# OWA DEPARTMENT OF NATURAL RESOURCES LAND & WATERS BUREAU WALLACE STATE OFFICE BUILDING

Fort Atkinson State Preserve Exterior Masonry and Structural Repairs Winneshiek County, IA PROJECT NUMBER: 24-03-96-01

January 12, 2024

G0

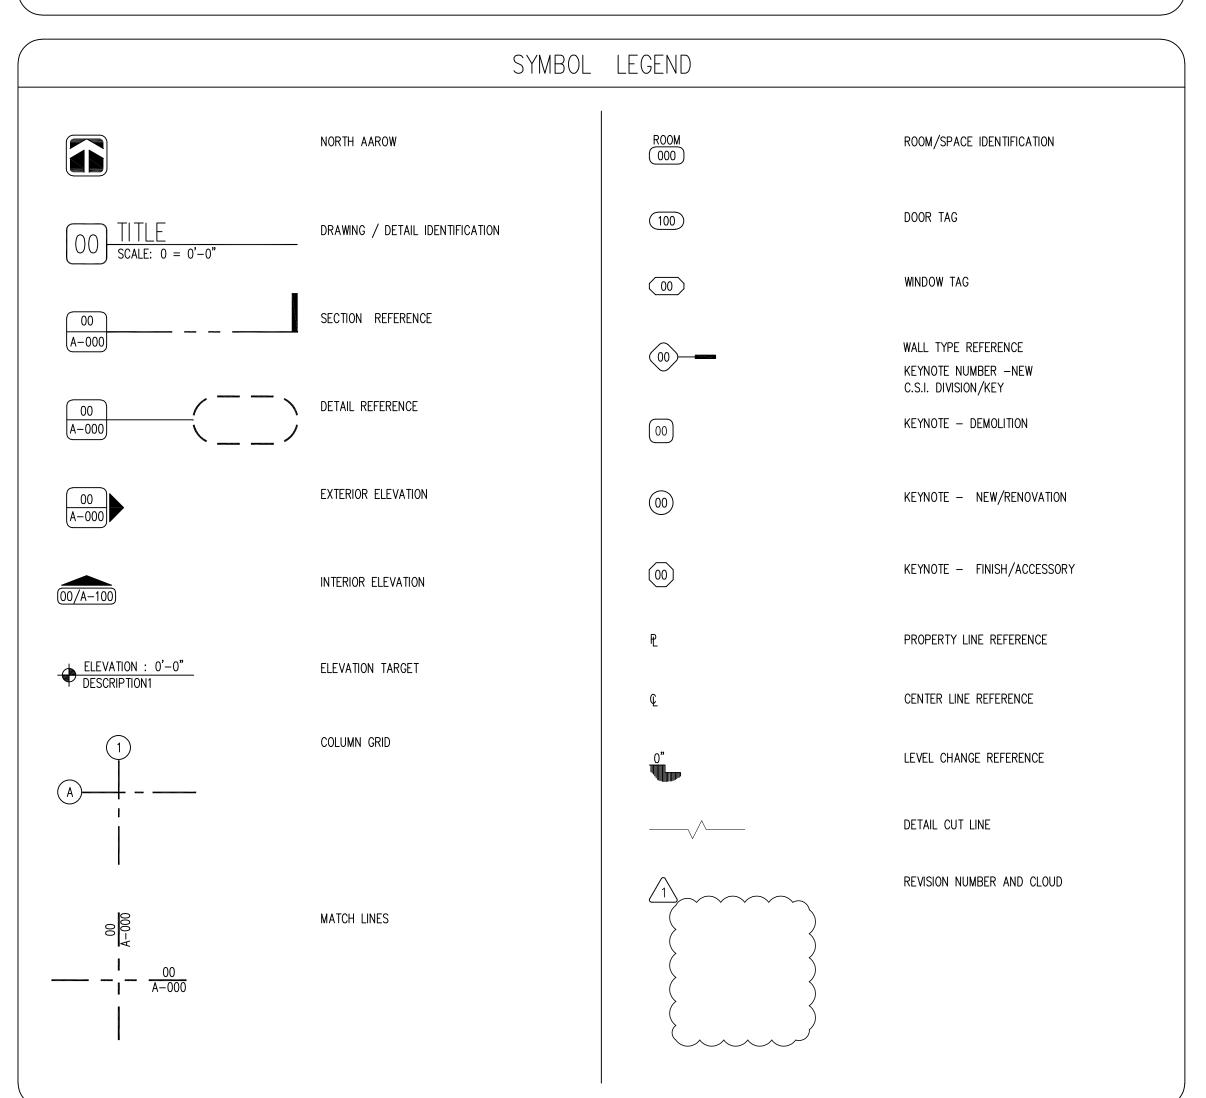
A. Sheet G0.1: has been modified (attached) to reflect funding statement requirements by National Parks Service:

Repairs at the Fort Atkinson Historic District are being supported in part by a Save America's Treasures grant from the Historic Preservation Fund administered by the National Park Service, Department of the Interior.
